Addendum No. 1

BULK CARGO DOCK PLATFORMS

September 11, 2020

Figure 1 – Design loads for new concrete arc platforms at Bulk Cargo Dock.

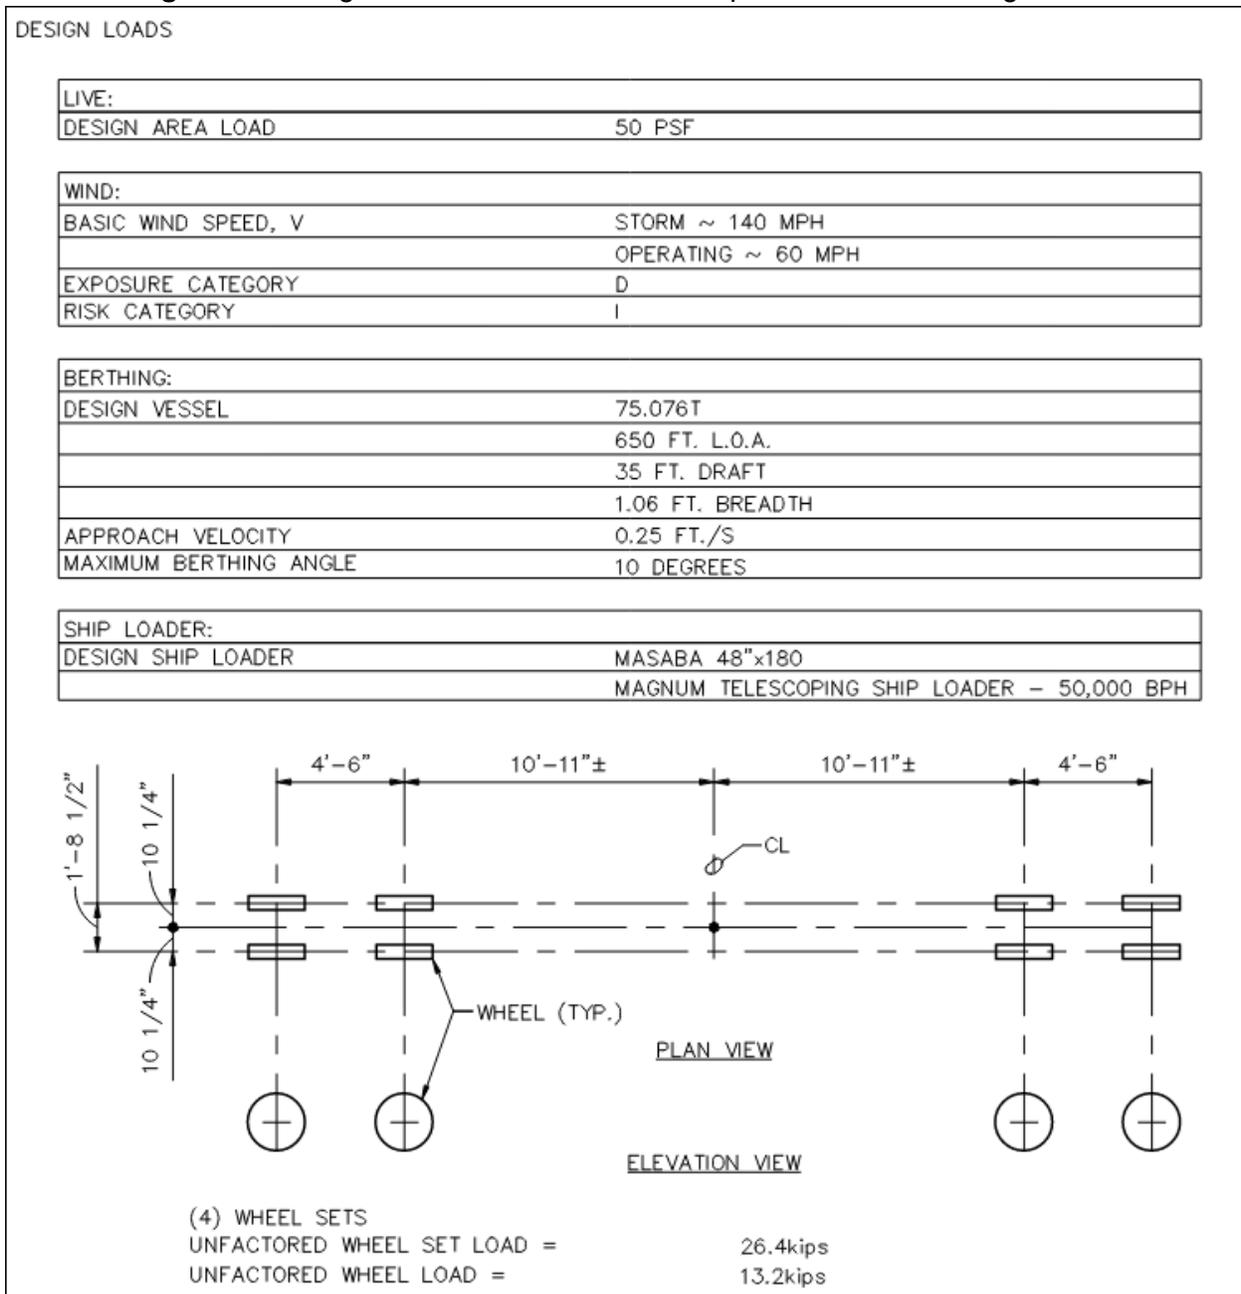
4. What is the weight limit for the existing portions of the dock?	The deck of the old dock has a 50 PSF weight limit. The new concrete arcs design load is shown in Figure 1 on page AD1-4 of 4
